TRANS/WP.29/GRSP/32
27 March 2003

REPORT OF THE WORKING PARTY ON PASSIVE SAFETY (GRSP)
ON ITS THIRTY-SECOND SESSION

AMENDMENTS TO DOCUMENT TRANS/WP.29/GRSP/2001/14/Rev.2
ADOPTED BY GRSP AT ITS THIRTY-SECOND SESSION

Figure 12 — ISOFIX low anchorage symbol

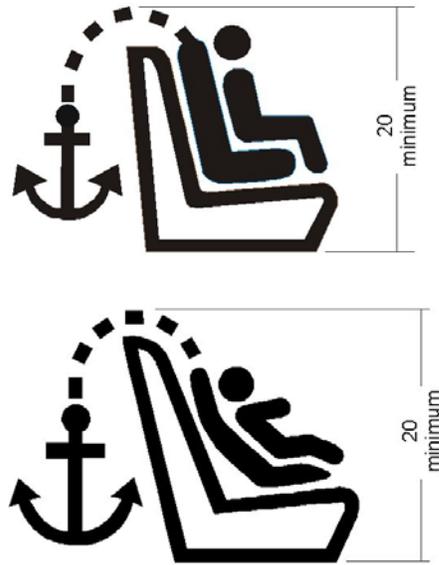
"5.2.3.6.1. As a minimum, the symbol of annex 9, figure 12 consisting of a circle with a diameter of minimum 13 mm and containing a pictogram, meeting the following conditions:

Insert new figures 12 and 13, to read:

1. Drawing not to scale.
2. Symbol may be shown in mirror image.
3. Colour of the symbol at choice of manufacturer.
